# **REMARKS**

# Appl. No. 09/750,386 Reply to Office Action of April 8, 2004 ANNOTATED SHEET SHOWING CHANGES

Fig. 2

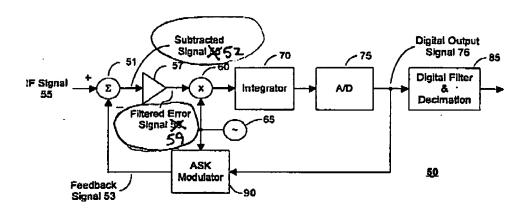
Figure 2 is objected to as containing informalities. By this amendment, in which a replacement sheet and annotated sheet is included, Applicant addresses the informalities noted by the Examiner. In view thereof, reconsideration of this objection is respectfully requested.
